# VAN'S AIRCRAFT

## NOTIFICATION 17-12-08

**Subject:** Canopy Latch/Handle Upgrade

**Affected Models:** All RV-12 Aircraft

**FIGURE 13:** CANOPY UPPER CENTER SEAL TOP VIEW

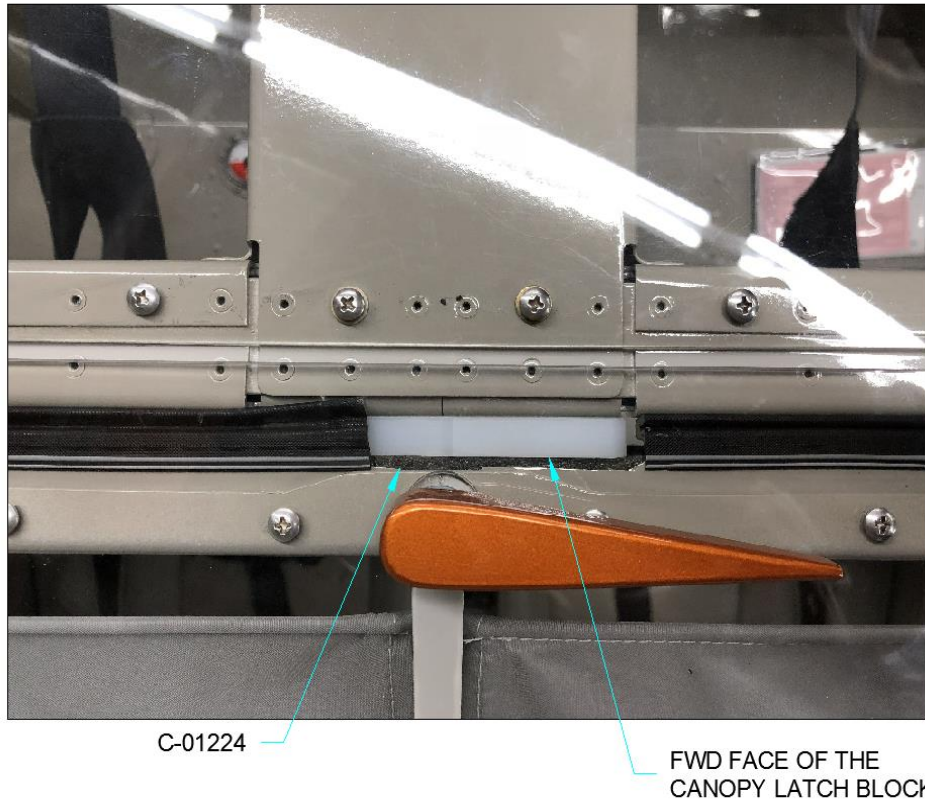
Step 19 (Seal Kit Installed): Trim the C-1220-L/R Roll Bar Seals to match the modified C-1221-L & R Seal Retainers. See Figure 12 and Figure 13.

Step 21 (Seal Kit Installed): Close the canopy. Looking straight down, place a piece of tape aligned with the forward edge of the canopy latch block. See Figure 13 and Figure 14.
